Re: Application Ref: 2016/4457/P: Objection To Proposed Replacement Of  
Horizontal Aluminium Sliding Sash Windows With Polyester Powder Coated  
Aluminium Casement Windows

RE: APPLICATION REF: 2016/4457/P: OBJECTION TO PROPOSED

(Windows at Flat 2d Millman Street, London WC1N 3EB)

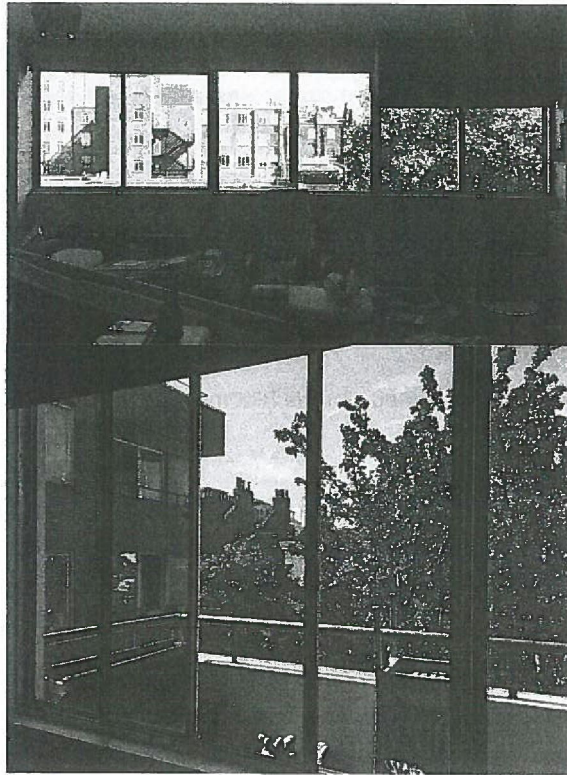
A notable feature of the buildings is the aluminium sliding windows. These are an integral element of the original design and are a 'trademark' element of Farrell and Grimshaw's work. For example, the windows of Grimshaw's iconic Park Road Apartment development in St John's Wood completed in 1968 <http://grimshaw-architects.com/project/park-road-apartments/> are identical to those at 1-19 Millman Street/Place.

See images of the Millman Street windows below for comparison.

As stated earlier, the aluminium sliding windows are integral to the design of the estate. The appearance of the building, which is of historic interest would be harmed by the removal of this original architectural feature.
